Window condition report, St. Andrew's Presbyterian, Victoria B.C.

A- Royal Canadian Navy

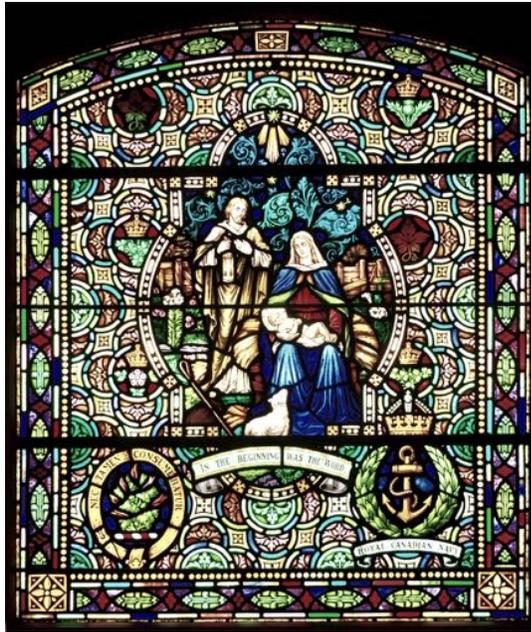
A - Royal Canadian Navy, no studio or date, as with 'A' to 'H', 55" wide X 66" tall

Generally firm, tight in rebate, pronounced deflection in the top panel (too tight?)

Two T-bars and two saddle bars, wire ties, all good

Protective glazing (PG) Plexiglass in light aluminum frame, clipped in place, unvented

Rating: 3.5 - monitor, vent PG

B - Canadian Scottish

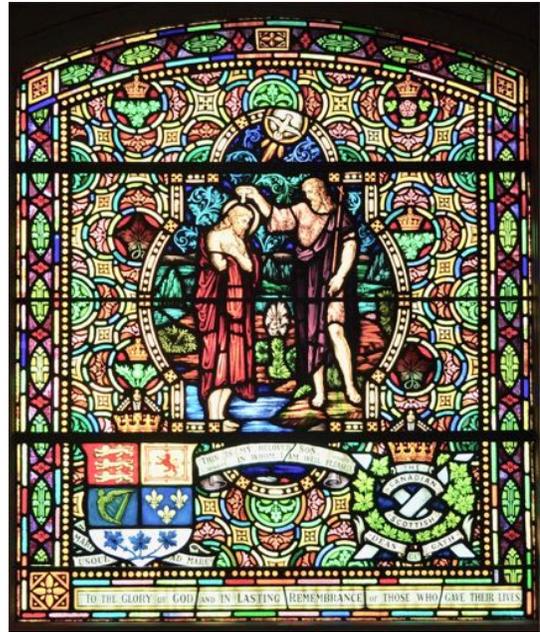
B - Canadian Scottish Regiment, 55" X 66"

Firm, flat, tight, steel bars and ties as in 'A', all in good shape

PG as in 'A', unvented

Rating: 4.5 - monitor, vent PG

P - Howe

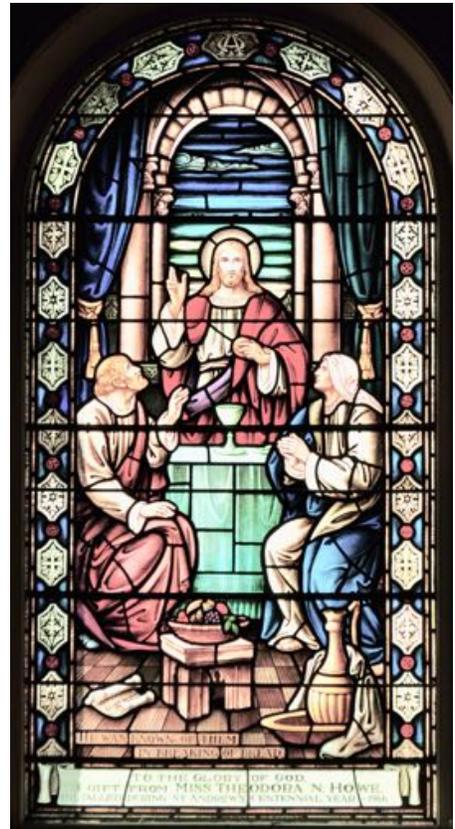
P - Howe, McCausland Studio, 1966, 59" X 115"

Fairly firm, flat, except severe deflection at bottom, chalice cracked, rest OK

T-bars caulked, otherwise bars/ties as above, good

Leakage noted as above

PG light aluminum frame missing, Plexiglass is severely bowed in (against stained glass) and out, loose, not secure

Rating: 3.5 - except 2.0 at bottom - monitor, plan to address lower panel and PG issues (including venting when properly installed)

One window does need to be remedied, the PG on the Howe window ('P') has come out of it's aluminum frame (some of the frame appears to be missing), is barely supported, and is bowing against the stained glass. Being a balcony window access is not simple. If a lift is provided to address this PG it would be prudent to vent all of the balcony windows on that side. Cost is difficult to arrive at until it is determined why this PG has failed so completely.

Q- Dunsmuir (4) and R - Rose and Tracery

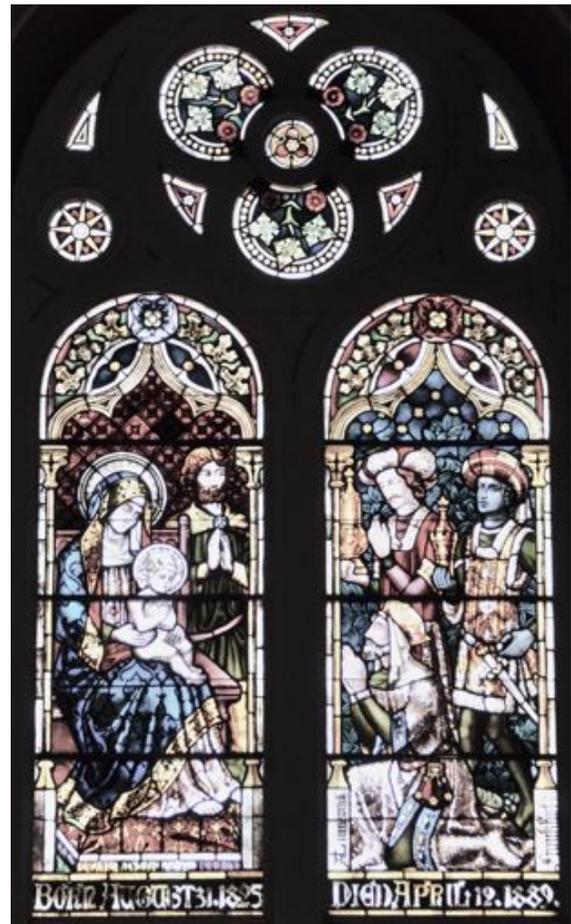
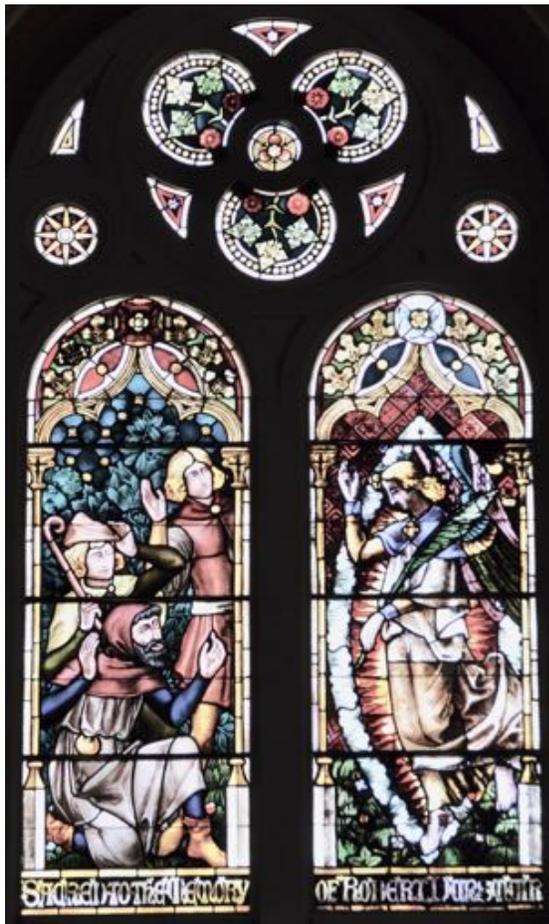
Q - Dunsmuir, by A. Linneman, Frankfurt, 1889, two pairs, each window 33" X 94"

Three T-bars each, some silicone caulking, scant room on T-bars to interior to hold window, no method of attaching windows to T-bars (top right panel actually bowed inward past edge of T-bar, showing daylight)

Were four light flat bars originally per window, two are now missing, three are partly detached, soldered on one side only as improper attachment to panels

Paint condition is compromised and fragile, some missing, probably due to borax flux sometimes used in late 19th century, found to be deficient

PG - installed in rebate with stained glass pressed tight against it, (hence scant room to interior on T-bars), unvented, no effective air movement even if vented, evidence of trapped condensation between stained glass and PG

Rating: 1.5 - Top right panel, remove, flatten/relead, add missing bar, install with effective attachment to T-bar

2.0 - Installation, all windows - address T-bars and lack of attachment

3.0 - General condition - though all should be removed, missing bars and T-bar issue addressed, and reinstalled without PG

1.5 - PG - Four Dunsmuir windows should be removed and reinstalled with a different method of providing properly vented and spaced PG (or no PG)

R - Rose Window and Tracery, no studio or date noted, perhaps not by A. Linneman

Firm, flat, (previously rebuilt), tight, no bars (inadequate)

PG as above

Rating: 3.5 - monitor, remove, add bars and reinstall without PG

Y - Clock Tower (4) and Sash Detail

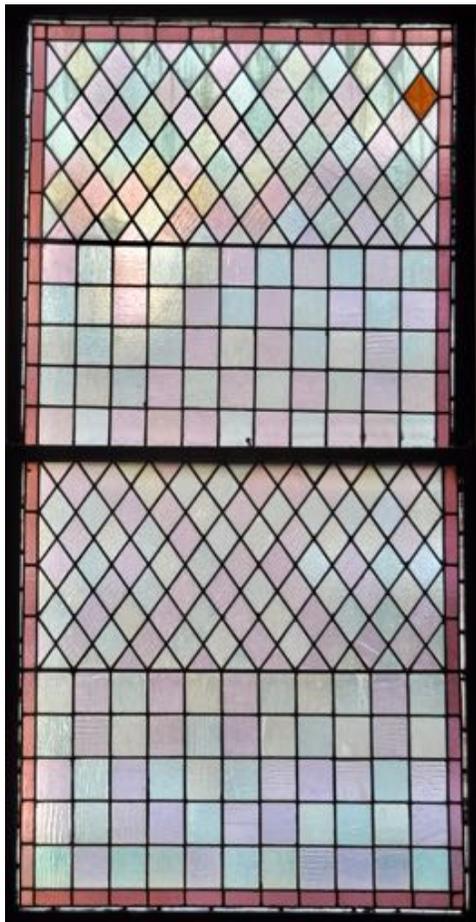
Y - Clock Tower, four round, each 41" dia.

Very soft ('floppy'), loose, weak, very poor condition

Two thin flat bars soldered to each, many solders on bars broken (one fallen off)

No PG

Sash in need of attention as well

Rating: 1.0 - danger of collapse, restore, and attend to sash

Cost: \$12500.00 - remove, cover the openings, restore the windows, and install in existing sash. The sash need attention as well, with costs determined once they are removed.
